# Access Compliance Report

### (Curb Ramps)

Intersection ID: 17505	Main Street: CRAIG_AV	Cross Street: N_SHARON_AMITY_RD	Location: NW
ADA ID: EDD08B1F4B1D	Ramp Type: PerpDiag	Initial Pass/Fail: Fail	Overall Compliance: No
Severity Score: 22.5			
Codes/Mitigation Info/Possible Solution		Field Measurements/Component Compliance

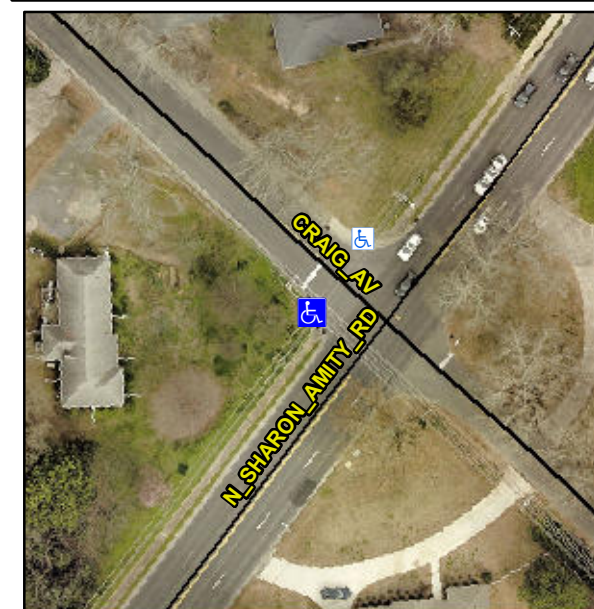
**Not Found, R304.5.1, R304.2.2, R304.5.3**

Compliance	Description	Data	Compliance	Description	Data
N/A	Ramp Length (in)	60.0	No	Ramp Slope (%)	9.9
No	Ramp Width (in)	38.0	No	Ramp XSlope (%)	4.0
N/A	Flare Type LT	N/A	N/A	Flare Type RT	N/A
N/A	Flare Slope LT (%)	N/A	N/A	Flare Slope RT (%)	N/A
N/A	Flare Traversable LT?	N/A	N/A	Flare Traversable RT?	N/A
N/A	Landing Length (in)	N/A	N/A	DWS Provided?	N/A
N/A	Landing Width (in)	N/A	N/A	DWS Contrast?	N/A
N/A	Landing Slope (%)	N/A	N/A	DWS Length (in)	N/A
N/A	Landing X Slope (%)	N/A	N/A	DWS Full Width?	N/A
N/A	Landing Curb? (Y/N)	N/A	N/A	DWS Offset (in)	N/A
N/A	Shared Landing?	N/A			
N/A	Gutter Ponding?	N/A	N/A	Gutter Slope (%)	N/A
N/A	Gutter Lip Ht (in)	N/A	N/A	Gutter X Slope (%)	N/A
N/A	Painted X Walk1?	No	N/A	Painted X Walk2?	No
	X Walk 1 Direction	To SE		X Walk 2 Direction	To NE
N/A	X Walk 1 Width (in)	N/A	N/A	X Walk 2 Width (in)	N/A
	X Walk 1 Slope (%)	3.3		X Walk 2 Slope (%)	4.6
	X Walk 1 X Slope (%)	6.5		X Walk 2 X Slope (%)	2.3

N/A	Ramp inside XWalk1?	N/A	N/A	Ramp inside XWalk2?	N/A
	Road Slope (%)	2.7	N/A	Clear Space?	N/A
	Road X Slope (%)	5.2	N/A	Clear Space to XWalk (in)	N/A
N/A	Any Obstructions?	N/A	N/A	Storm Grate/Utility Hazard?	N/A
	Obstruction Type			Storm Grate/Utility Type	
		N/A			N/A
			Yes	Surface Condition? (G/P)	Good

**Remove & Replace Curb Ramp With Two New Directional Ramps or Equivalent.**
